January 25, 2019

**RE: Response to December 21, 2018 MDEP Technical Review Memorandum
New England Clean Energy Connect Project, L-27625-26-A-N**

GRAVEL WETLAND #1 PLAN
1"=20'

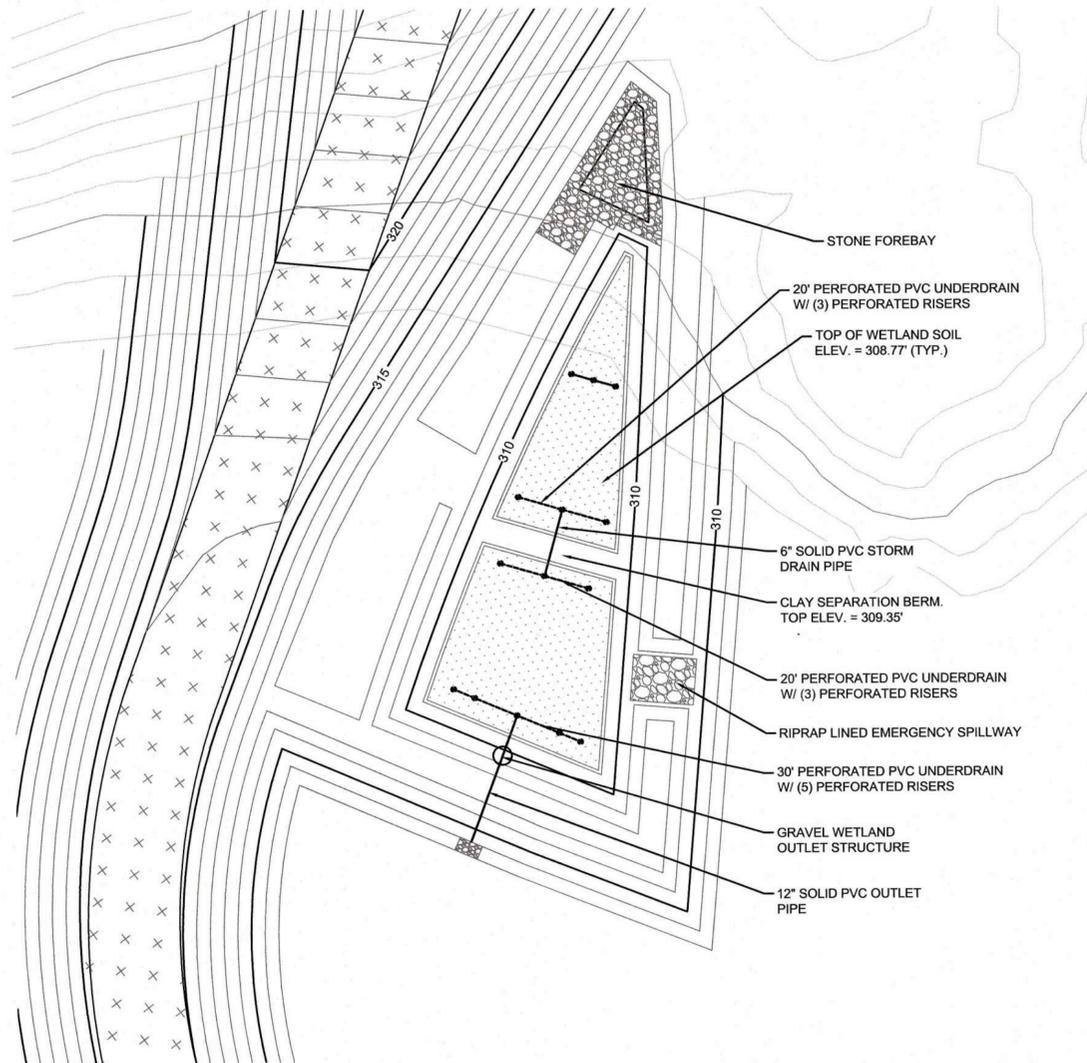
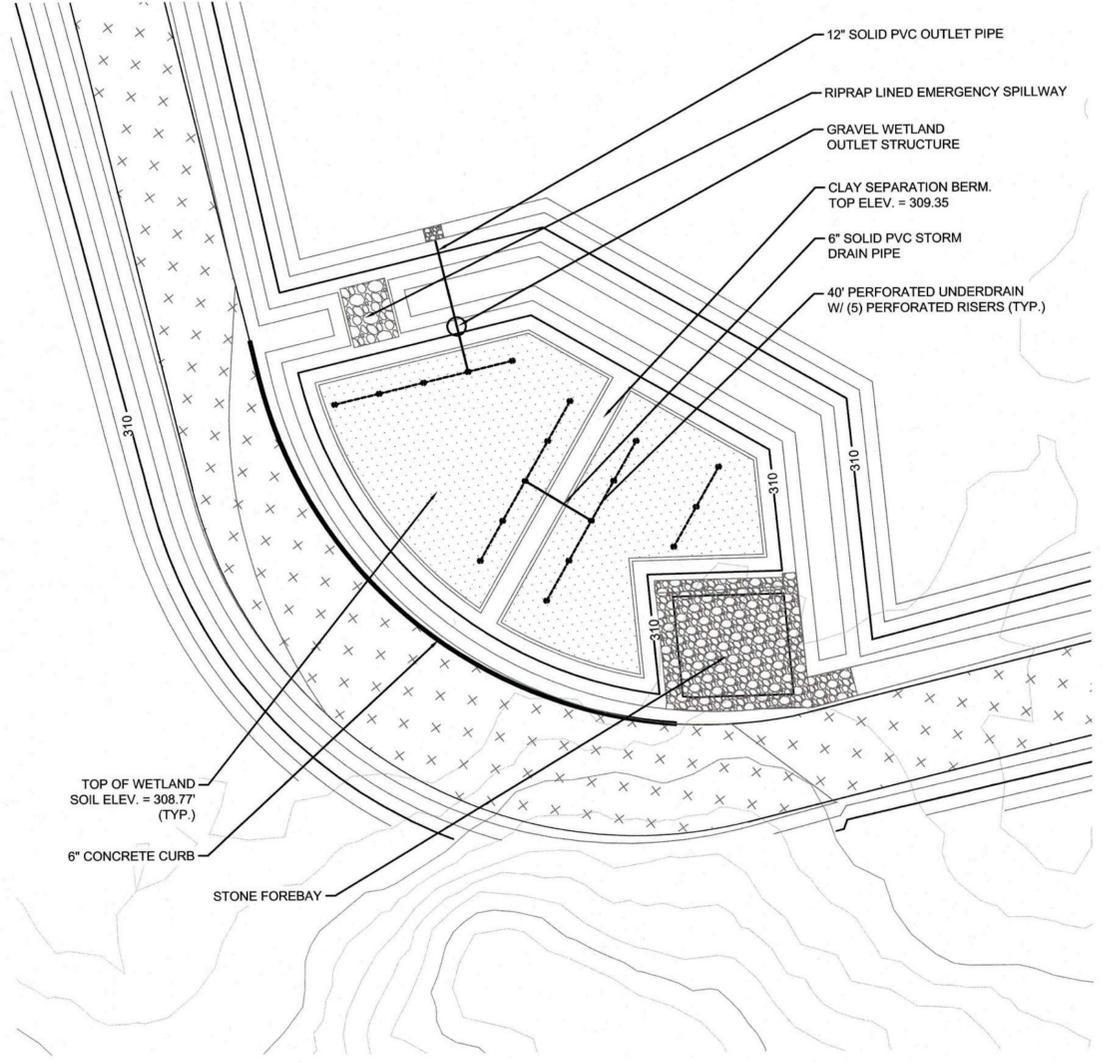
Please provide 1":20' or larger scale plan views of the proposed gravel wetlands that:

- a. Show location of the lateral underdrains in each cell,
- b. Show location and number of the perforated riser pipes in each cell. Please note that a riser must be provided for every 10 linear ft of the inlet lateral underdrains per Maine Stormwater BMP Manual Chapter 7.4,

- c. Revise the berms separating the cells. They must extend perpendicular to the flow direction without interruption and include a stable spillway. In the current plan views of the gravel wetlands (e.g. *1076-003-004 Sheet 1 of 2*), the berms appear to have a sizeable opening in the middle, which may prevent the intended ponding in the upgradient cell.

- d. Provide detailed grading and keynotes for *Gravel Wetland #1* forebay to ensure that the entire runoff enters the first/upgradient cell at a defined, stabilized (e.g. riprap spillway) entry point,

Plan views for each of the two gravel wetlands have been provided, at 1" = 20' scale, on new drawing 1076-003-002 SH 6 of 6 (Attachment E). In particular:

- The locations of the lateral underdrains in each cell are depicted;
- The locations and number of the perforated riser pipes in each cell are depicted;
- The berms separating the cells have been revised to extend perpendicular to the flow direction without interruption; and
- The grading in the vicinity of Gravel Wetland #1 has been detailed to ensure that the entire runoff enters the forebay, then on to the first/upgradient cell.

The grading in the vicinity of Gravel Wetland #2 has been revised so that the entire runoff enters one forebay. The forebay by Sta 10+00 remains and the other forebay has been removed. The runoff from the access road between Sta 8+00 and Sta 10+00 is directed to the forebay by a concrete curb.
